Amendments to the Drawings

Application No.: 10/722,466
Art Unit 1746

Attorney Docket No. 0465-1103P
Reply to September 27, 2006 Office Action
Page 14

FIG. 1
Prior Art

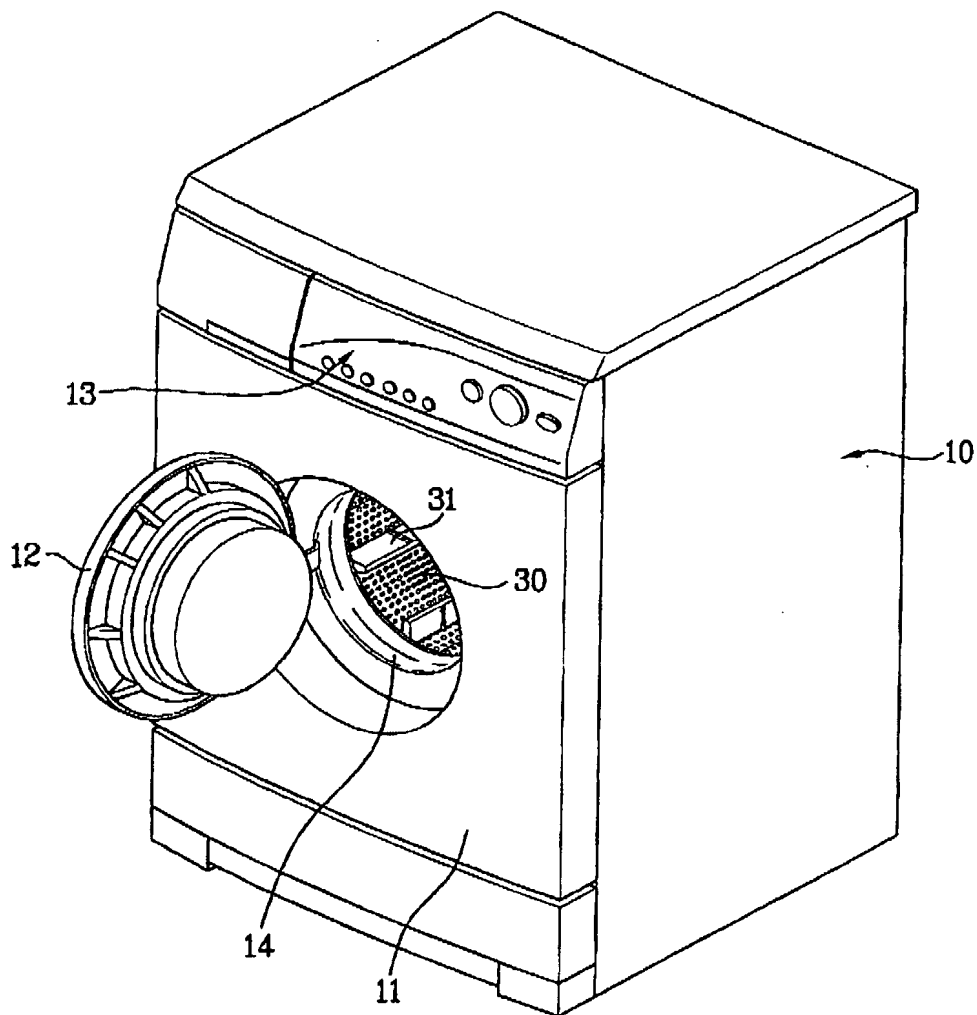
Figs. 1-3 are amended to include the legend - - Prior Art - -.

The Examiner has objected to the drawings because the drawing figures contains some labels that are not disclosed in the specification and do not show all labels disclosed in the specification, and because Figs. 1-3 are not labeled as prior art. This objection is respectfully traversed.

With respect to the suggestion to label Figs. 1-3 as "Prior Art," Applicants have labeled Figs. 1-3 as "Prior Art." Applicants submit that the drawing corrections filed herewith, which include the label "Prior Art", meet the criteria of MPEP § 608.02(g). Accordingly, reconsideration and withdrawal of this objection, and approval of the drawing corrections filed herewith, are

FIG. 3

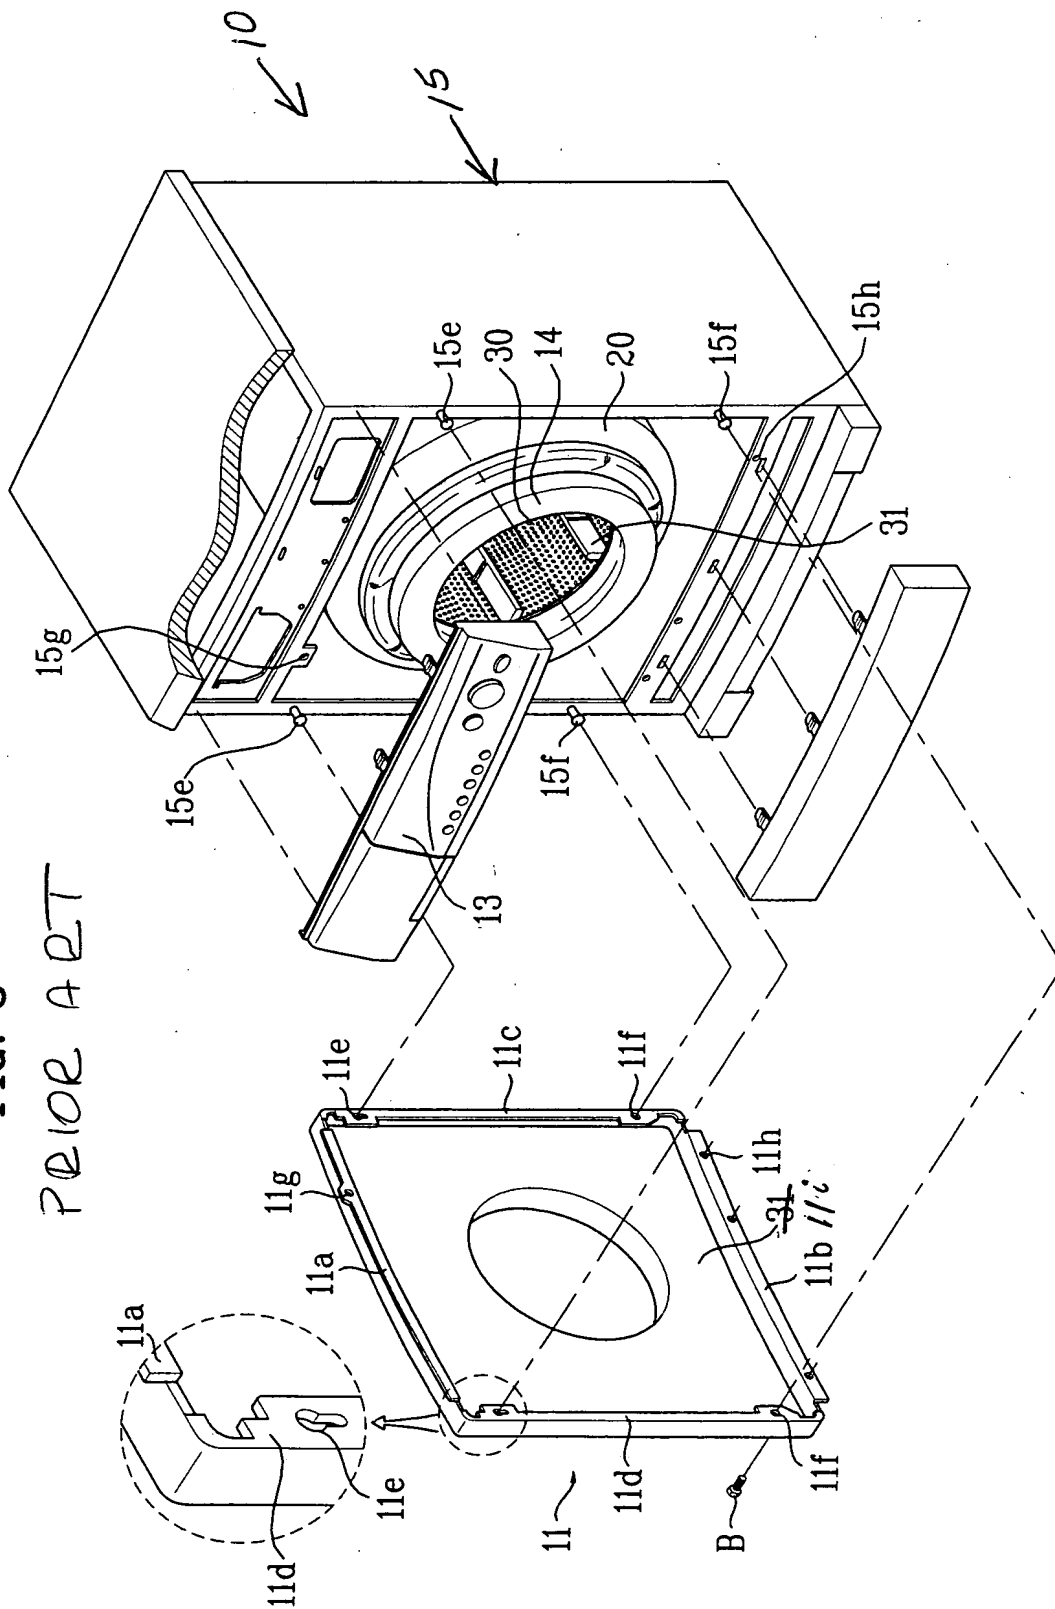
Fig. 3 is also amended by adding label numerals - - 10 - - and - - 15 - -, and by changing “31” to - - 11i - -.

Applicants thank the Examiner for the thorough review of the specification and drawings. Applicants have also further reviewed the specification and drawings with the Examiner's observations in mind, and are amending both the specification and drawings to make the specification and drawings consistent. Based on this further review, Applicants have determined that Fig. 3 labels two different elements with the same reference numeral, i.e., "31." To correct this informality, Applicants have replaced one instance of "31" with number "11i" in Fig. 3.

Applicants have also amended Fig. 3 by adding labels "10" and "15" based on the informalities noted by the Examiner.

FIG. 4

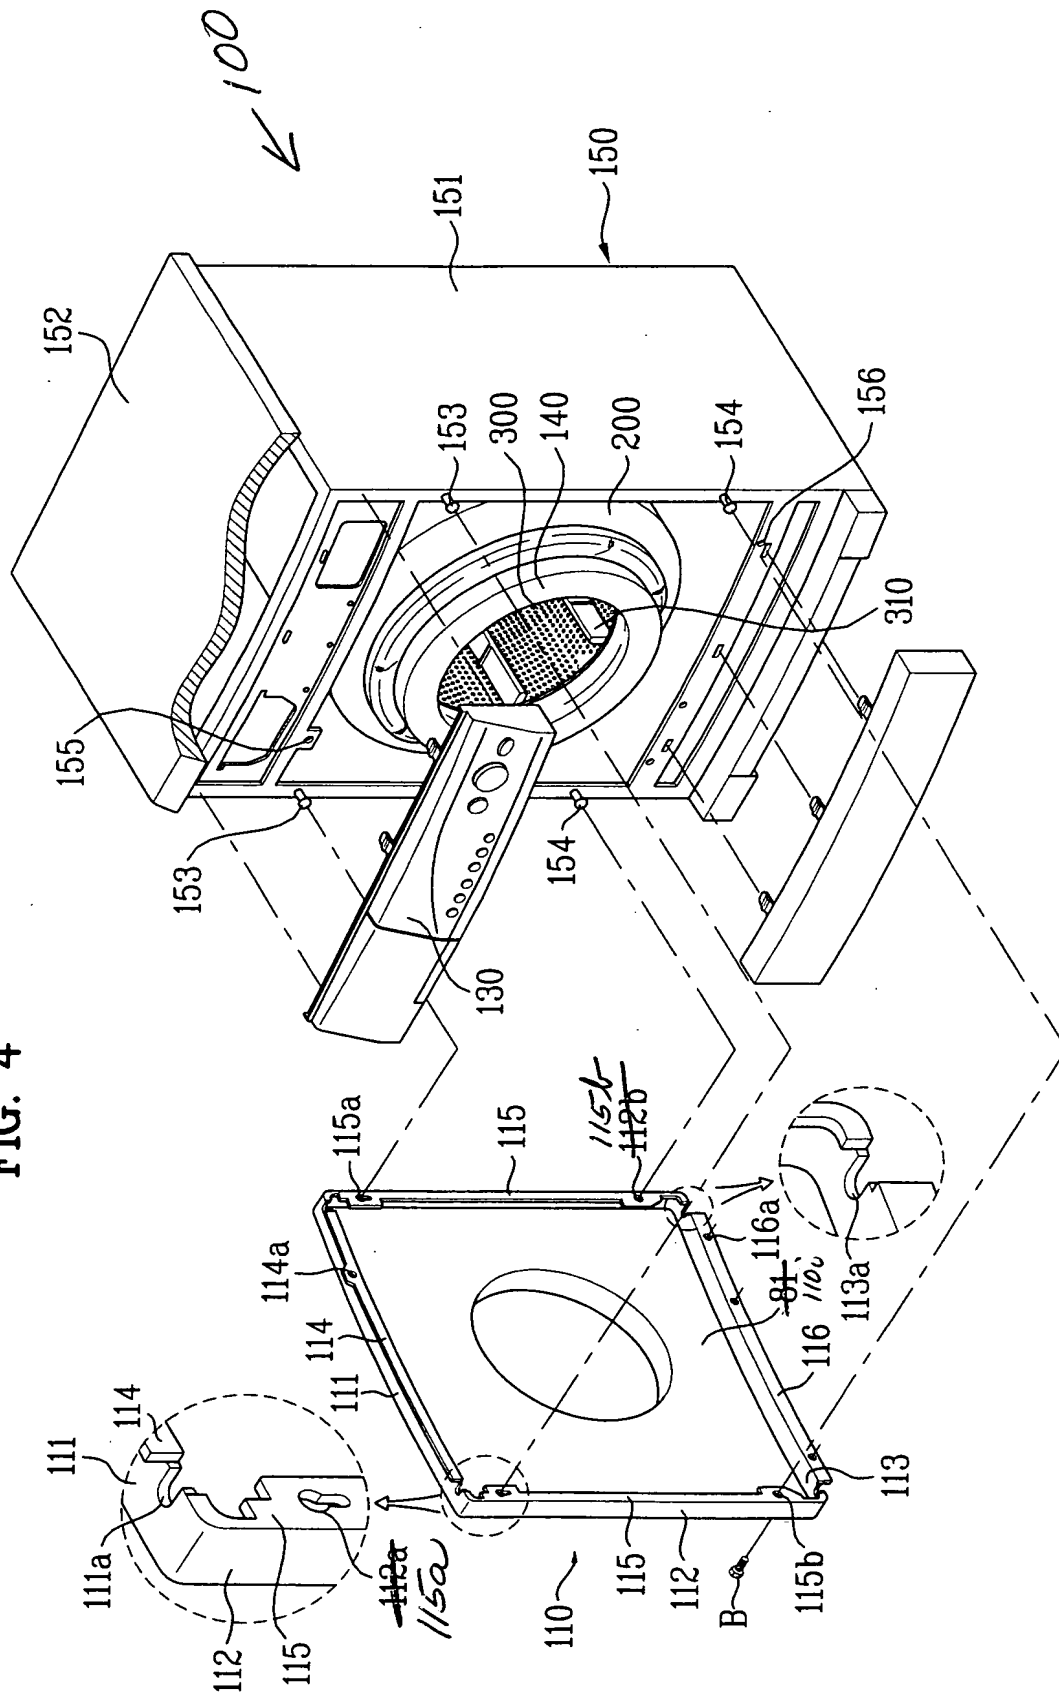
Fig. 4 is amended by changing “112a” to - - 115a - -; by changing “112b” to - - 115b - -; by adding - - 100 - -; and by changing “81” to - - 110i - -.

Applicants also respectfully submit that Fig. 4 does actually show tub 200 labeled as such, contrary to the assertion that element 200 is not shown in any drawing figure.

Applicants have also amended Fig. 4 by replacing "112a" with - - 115a - - and by replacing "112b" with - - 115b - -; and by adding cabinet label number 100. Also, to be consistent with the new label "11i" in Fig. 3, Applicants have replaced numeral "81" in Fig. 4 with - - 110i - -.
